UNITED STATES PATENT AND TRADEMARK OFFICE

10/752,700

Office Action Summary	Application No. 10/752,700	Applicant(s) KUWADA ET AL.	
	Examiner Matthew W. Such	Art Unit 2891

DETAILED ACTION

FIG. 6F

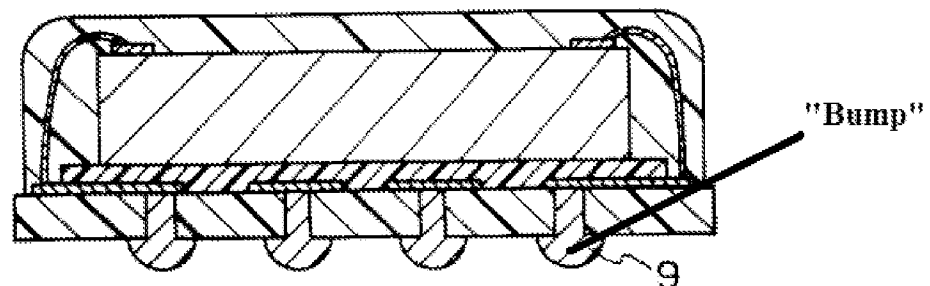
23. Regarding the rejection of claims 1-2 under 35 U.S.C. 102(b) as anticipated by Yamamoto ('404): The Applicant argues that Yamamoto does not show a semiconductor device bonding to a substrate through a bump bonding part (see Applicant Remarks page 12). This is not persuasive for at least the following reasons. Firstly, Yamamoto clearly shows a "bump bonding part" (Element 9) which mount the semiconductor element (Element 6) to a substrate (Element 4). The Applicant's asserts that Element 9 of Yamamoto is a "wiring" (see Remarks Page 12) is not persuasive because each of the terms of "bump bonding part" is not claimed with sufficient specificity to distinguish a "bump bonding part" from Element 9 of Yamamoto. Element 9 of Yamamoto is a "part" because it exists, it has a "bump" (as shown below) and "bonds" because it is attached.

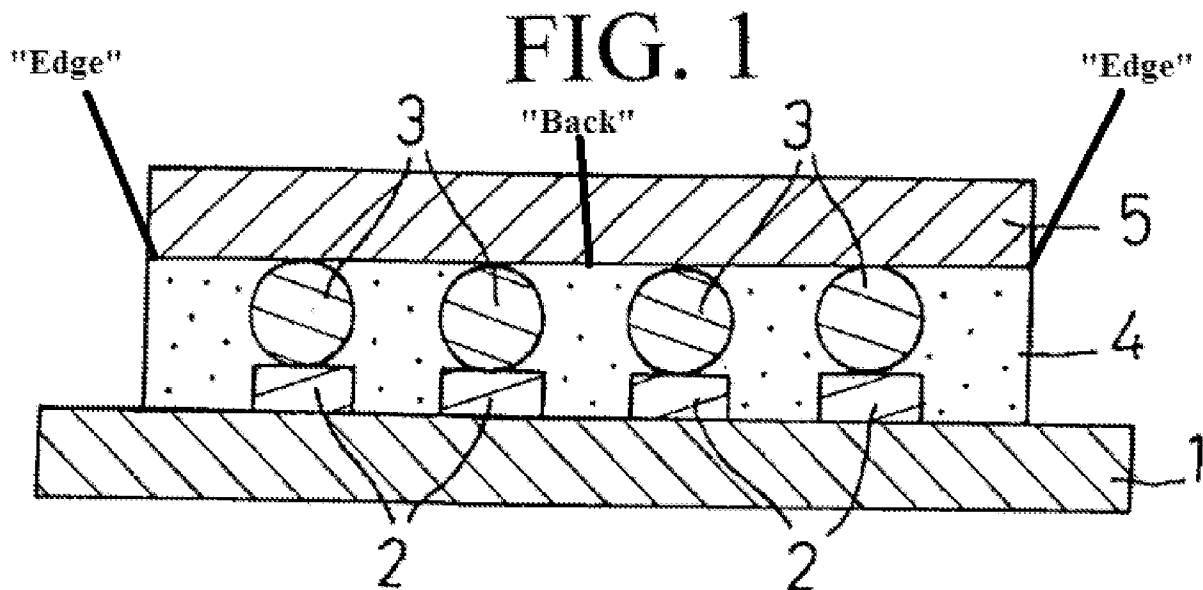
24. Regarding the rejection of claims 1-2 under 35 U.S.C. 102(b) as anticipated by Hotta ('096): The Applicant argues that the prior art reference of Hotta does not anticipate the claims because "there is no description about encapsulation with a sheet having tackiness". This is not persuasive for at least the following reasons. Firstly, the claim does not distinguish what structural features of the recitation of "sheet" to distinguish the claim from the prior art of Hotta. Since the element of Hotta is a long and thin feature, it must be a "sheet". Hotta even refers to the element as a "sheet" (see Col. 5, Lines 65-66, for example). Furthermore, the material of Hotta has "high adhesion" and therefore must have some level of tackiness since tackiness is merely a measure of adhesiveness.
